Product Change Notification

Change Notification #: 118095 - 00
Change Title: MINOR CHANGE, Restriction of Hazardous Substances (RoHS), PCN 118095-00, Label, Transport Media, Removal of RoHS Verbiage Used on Labels & Removal of Green RoHS Sticker on Silicon Product Shipping Box Labels
Date of Publication: February 26, 2021

(Example of a standard intermediate box label (I-box) where the verbiage is removed, forcing any remaining values to be left justified)

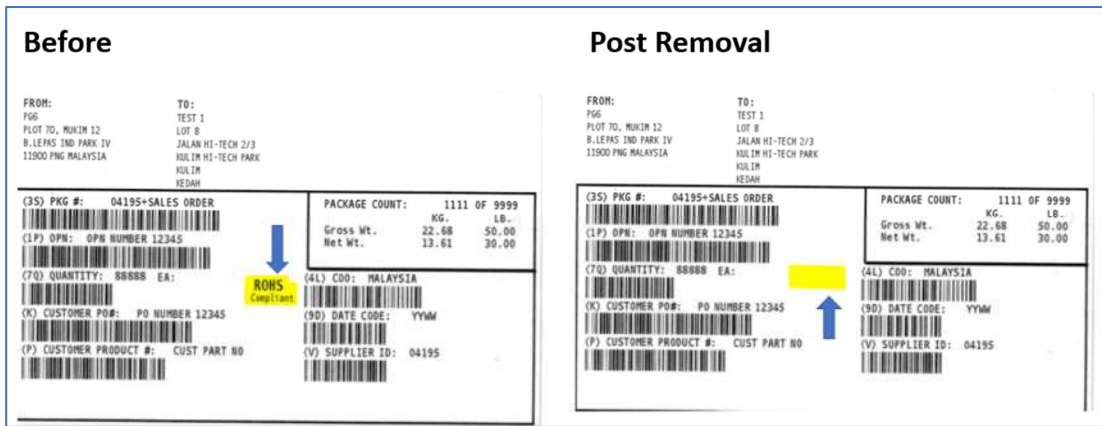
1. On all labels used in packaging or shipping, wherever the words “RoHS Compliant” are seen, this verbiage will be removed completely.

Without listing ALL possible label examples herein, below are just two examples demonstrating the removal of the verbiage “RoHS Compliant”.

(The green pre-printed sticker would appear just below any standard/custom label and this graphic/picture is for illustration purposes only)

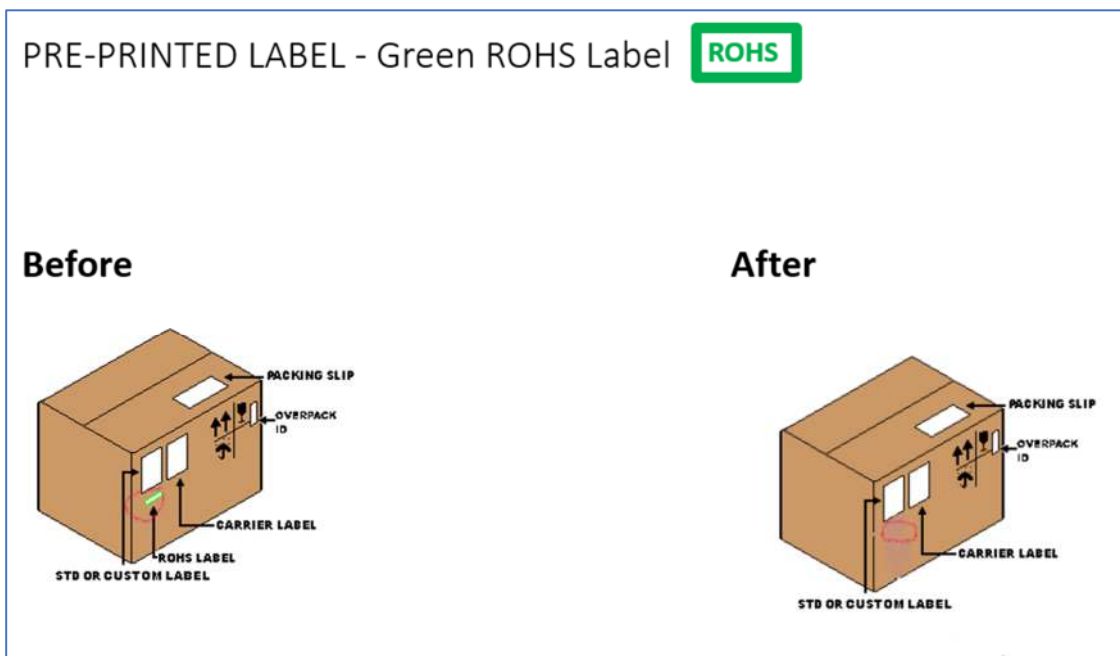
- The removal of a pre-printed green RoHS sticker on the Shipping Box used for Silicon Products. The Pre-Printed Green RoHS Sticker, if still seen on a Shipping Box will no longer be used.
